**FINAL
RECORD OF DECISION
OPERABLE UNIT 1**

**GEORGE AIR FORCE BASE
CALIFORNIA**

APPENDIX B **RESPONSE TO AGENCY COMMENTS**

11. Figure 9, Conceptual Design of Extraction and Monitoring Wells

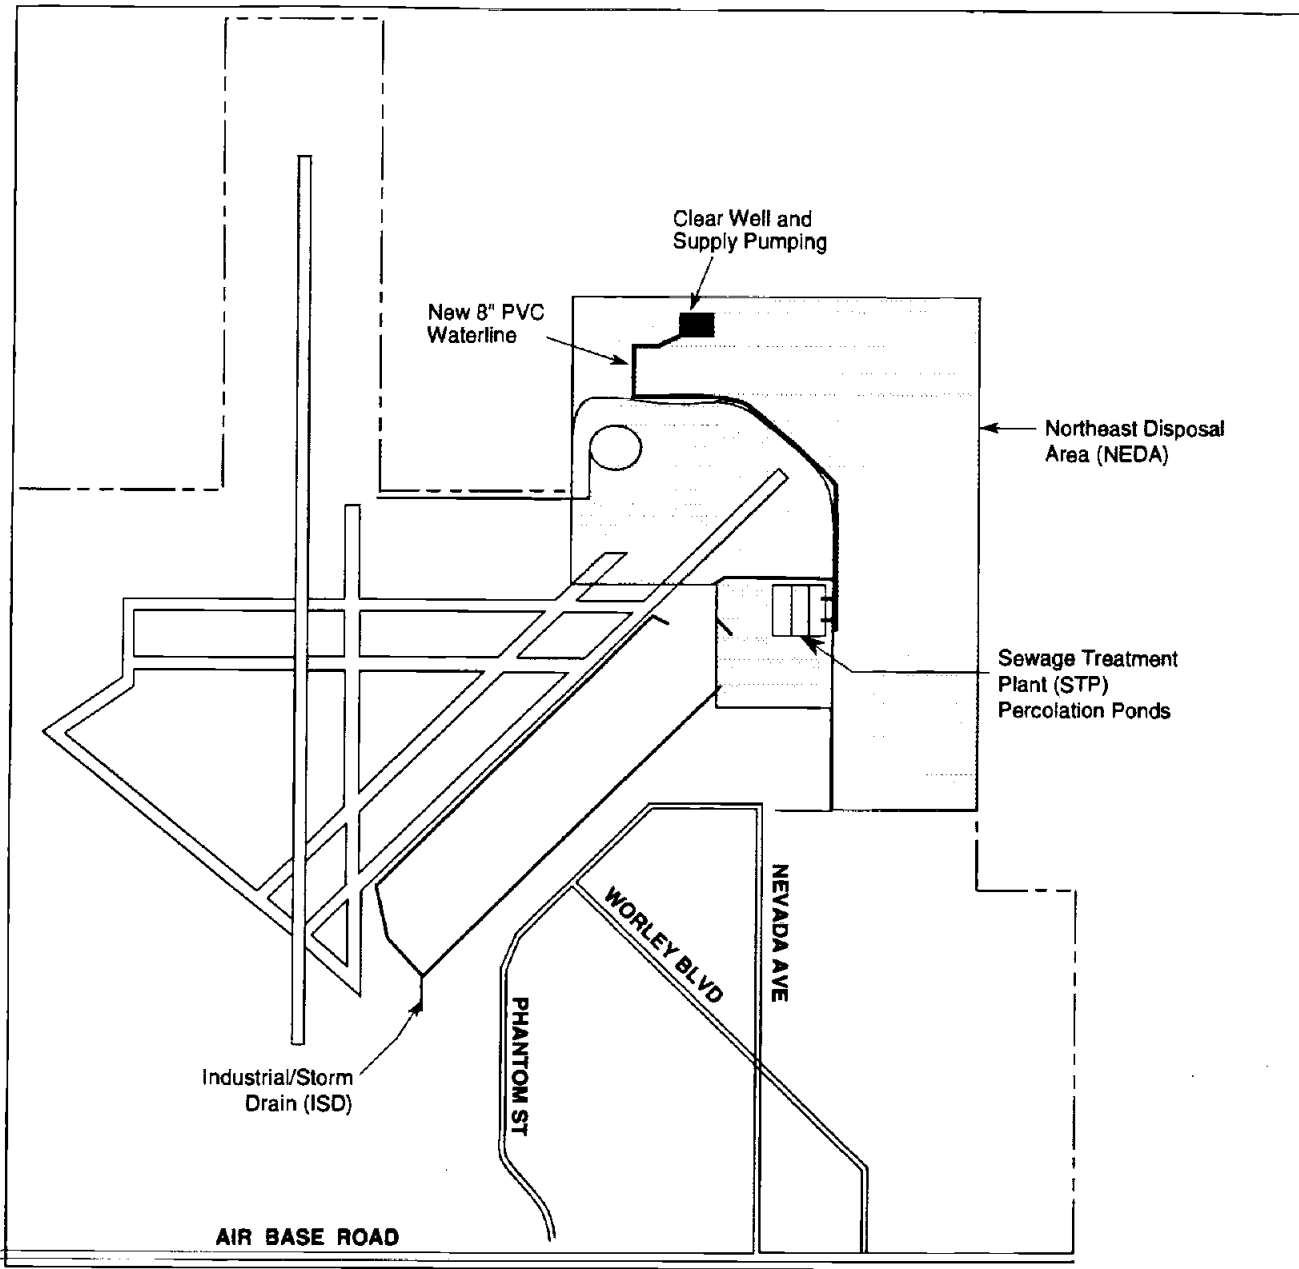
This figure is misleading. It should be revised to note what facilities are completed as part of Phase I and what facilities are proposed (or necessary) for Phase II. To better illustrate the proposed remedy, we suggest another figure be included to show all proposed Phase II well locations (see final FS, Figure 5-1). The figure should clearly indicate that the locations may be modified as necessary to maximize plume containment and capture, based upon a future capture zone analysis and review of Phase I treatability study data.

3. Figure 9, add to Title box:

1. The text has been modified to state that the wells "were, but are not currently used for potable water."
2. The text has been modified accordingly.
3. The title of Figure 9 has been modified to clarify that it shows Phase I of the extraction/treatment system. The text now states that because the exact number and location of extraction wells for Phase II is pending determination of Phase I efficiency, they are not shown on Figure 9.
